### Application for Variation of Premises Licence

Ayrshire Entertainments Limited	Ye Olde Forte Bar 39 South Harbour Street Ayr
Removal of the condition 2 - "There sha	all be no live music on the Premises"

### SUBJECT:Licensing (Scotland) Act 2005Premises:Ye Old Fort Bar, 39 South Harbour Street Ayr, KA7 1JA

#### EHS response to Ye Olde Forte Bar acoustic report.

Photo 2.3(d): lowered ceiling detail of main bar area (15/07/24)

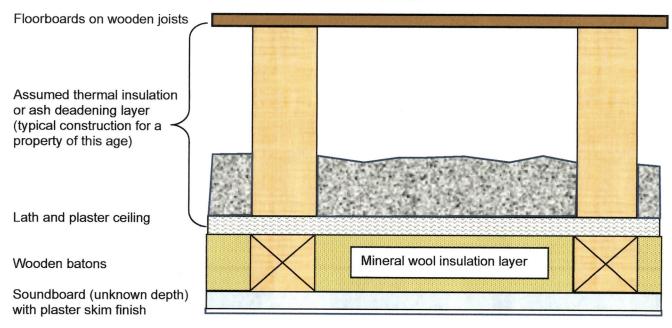
However, there are some unknowns, particularly pertaining to the construction of the premises and particularly with reference to the mitigation properties of the ceiling space to the flat above.

This could result in noise nuisance conditions existing, even if the noise management procedures within the report are followed, once music entertainment commences. While this service welcomes that there will be no amplified music after 9pm, the applicant should be aware that nuisance conditions can still occur prior to this time.

In view of this, Environmental Health would be duty bound to investigate further, should this situation arise.
